design & access statement

pre application
comments on layout

project:
Proposed residential development
Overton on Dee, Wrexham. **SITE B2**
SKETCH LAYOUT 01.
03-06-2019

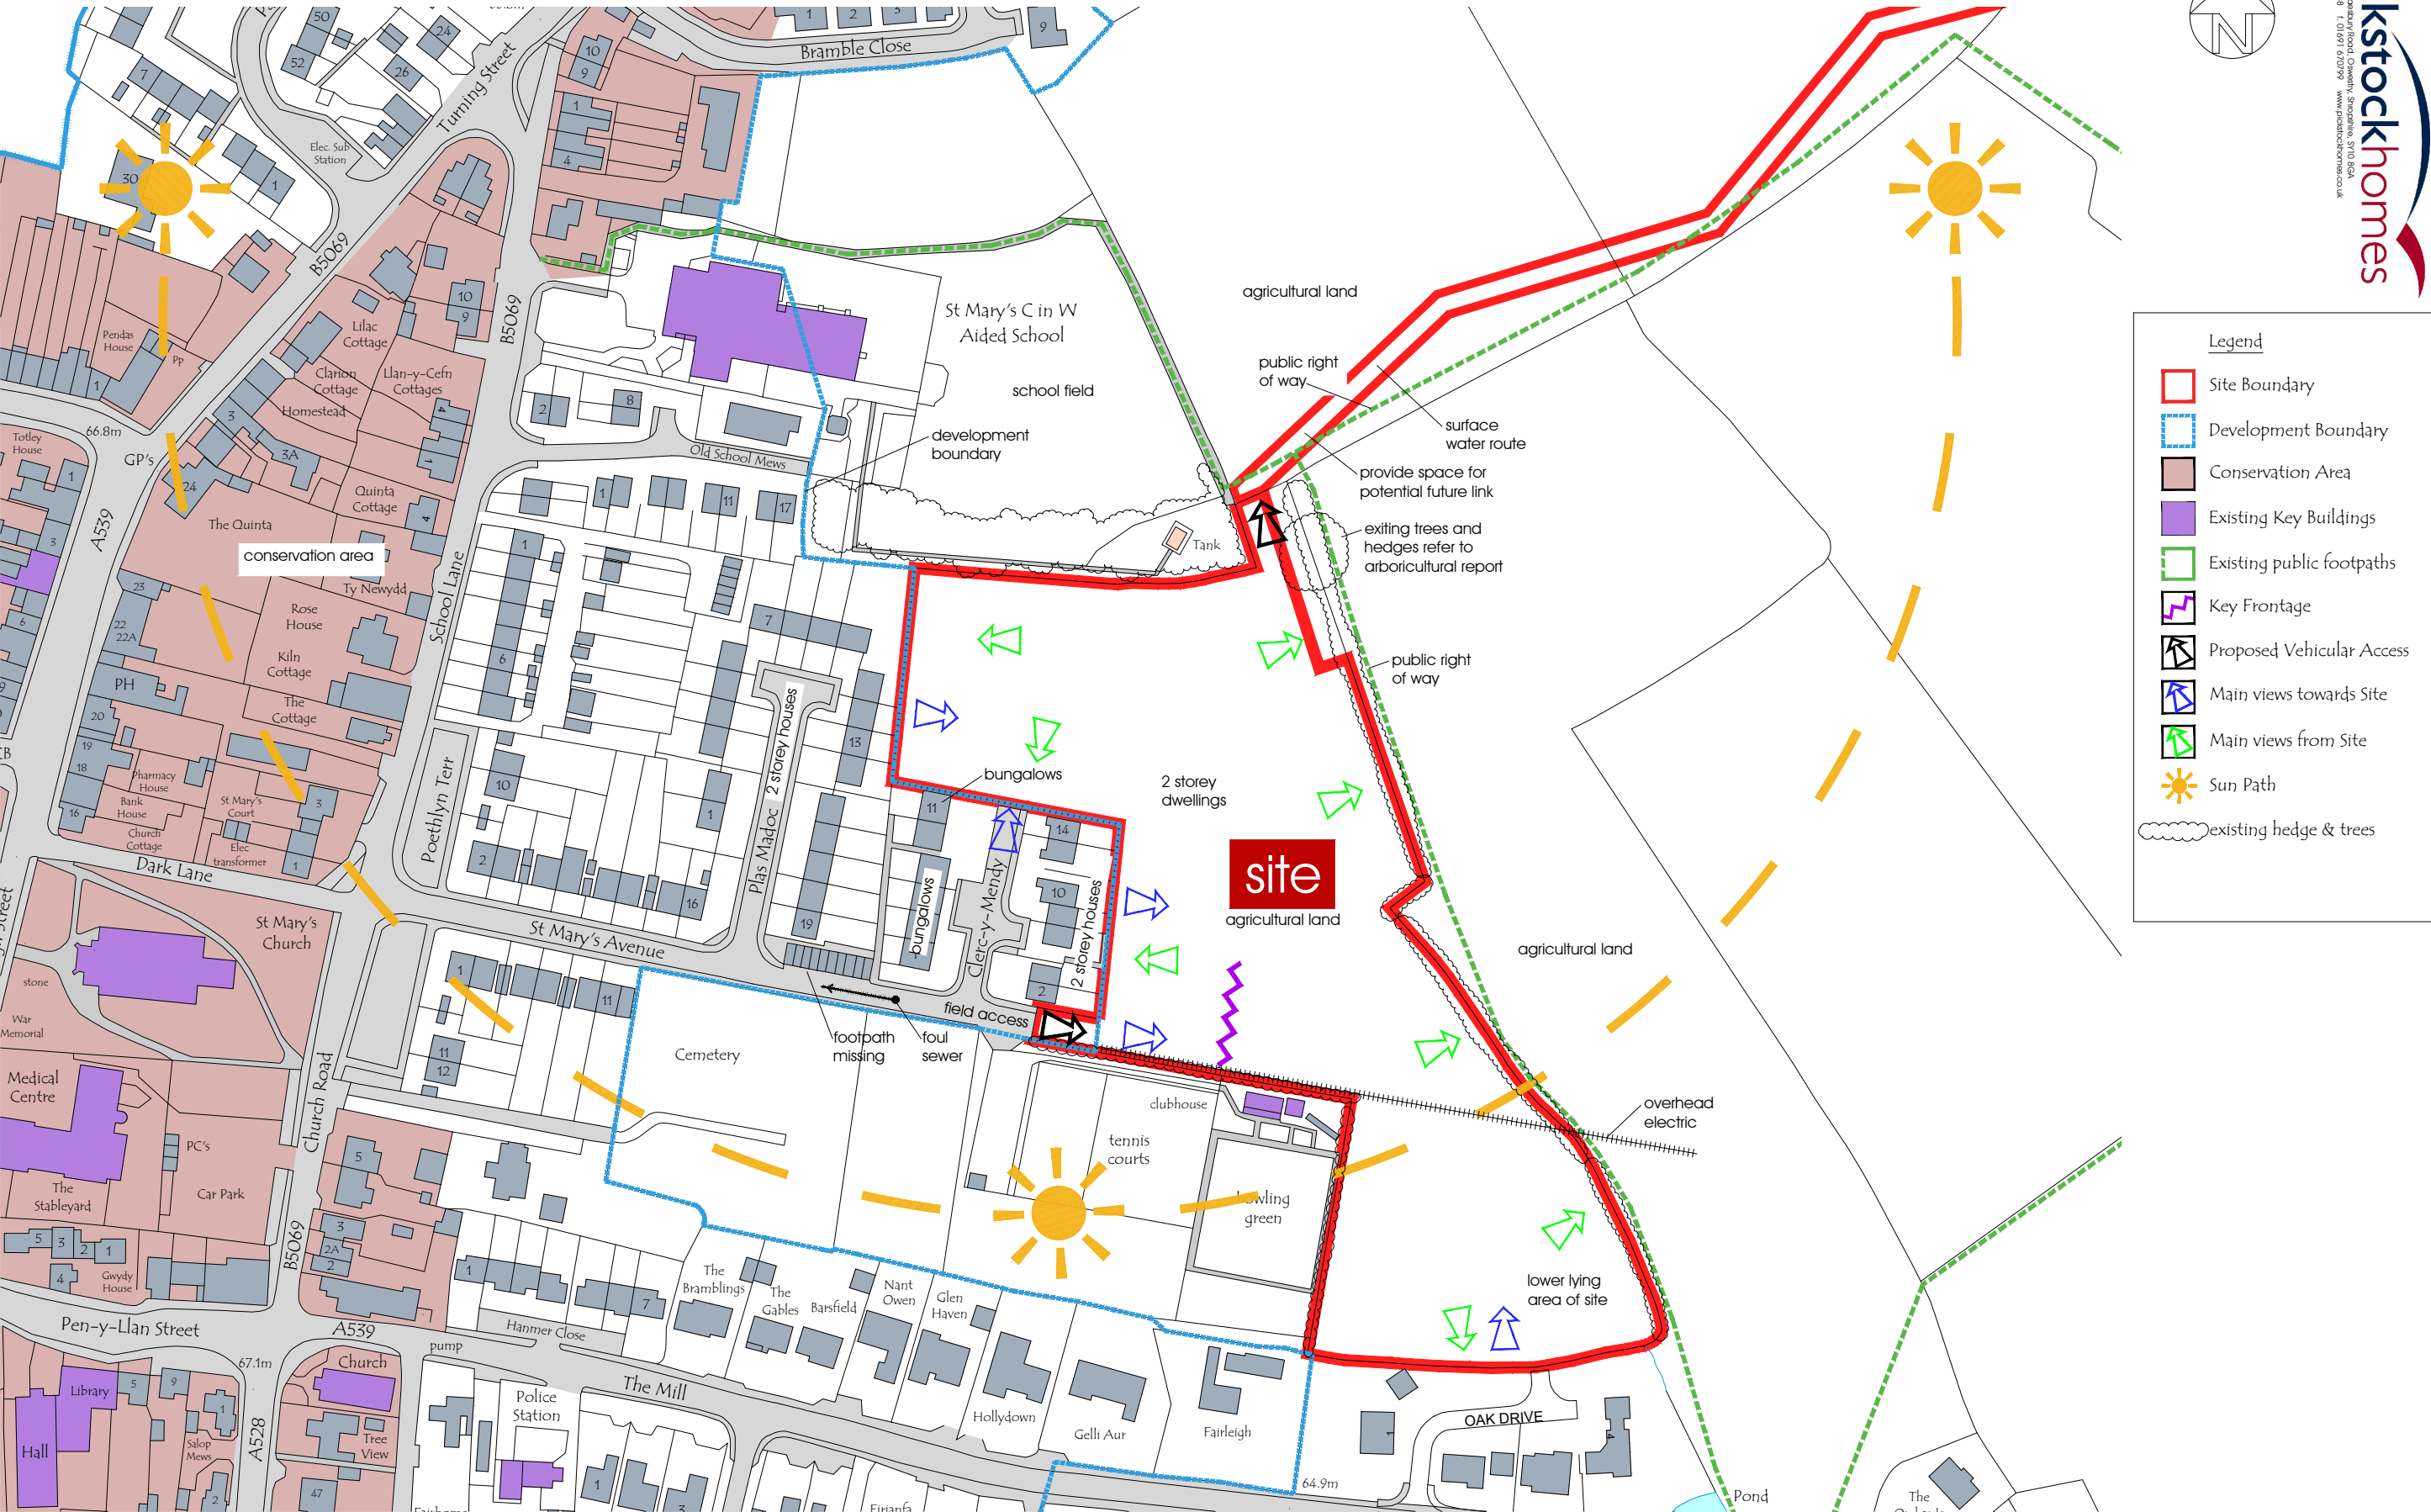
pumping station
will be required,
foul sewer in St
Mary's Avenue

no sense of place
at site entrance

integrate into layout
the smaller dwellings

reduce dominance
of car parking

dwelling set too far back from entrance

POS to be overlooked

poss link to
PROW 18

consider
PROW 18

potential future access to
be provided for land owner

no site
closure

layout to cramped

no pd

Southern area of site difficult drain for surface water due to levels

better integration of rural edge of site against open country side
